CONCORD PUBLIC SCHOOLS

BIDDING DOCUMENTS: ADDENDA
for the purchase and installation of
FOOTBALL FIELD LIGHTING IMPROVEMENTS

Tuesday, September 29, 2020

Addenda to Scope of Work

Figure 1: Football Critical Minimum Zones (minimum 50 FC within the shadowed area below)

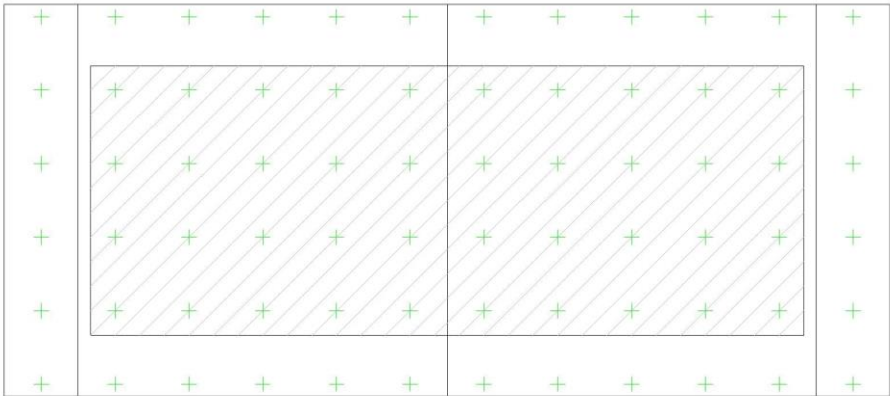
Performance Requirements: Playing surfaces shall be lit to a target **average illuminance** and target **minimum illuminance** levels and uniformities as specified in the chart below. Horizontal lighting calculations shall be developed, and field measurements taken on the grid spacing with the minimum number of grid points specified below. Measured average illumination level shall be in accordance with IESNA RP-6-01.

Area of Lighting	Guaranteed Average Horizontal Light Levels	Maximum to Minimum Uniformity Ratio	Minimum Level – Entire Field	Critical Minimum Level	Grid Points	Grid Spacing
Football Field 360'x160'	50 FC	1.5:1	24 FC	50 FC (See Fig 1)	72	30' x 30'
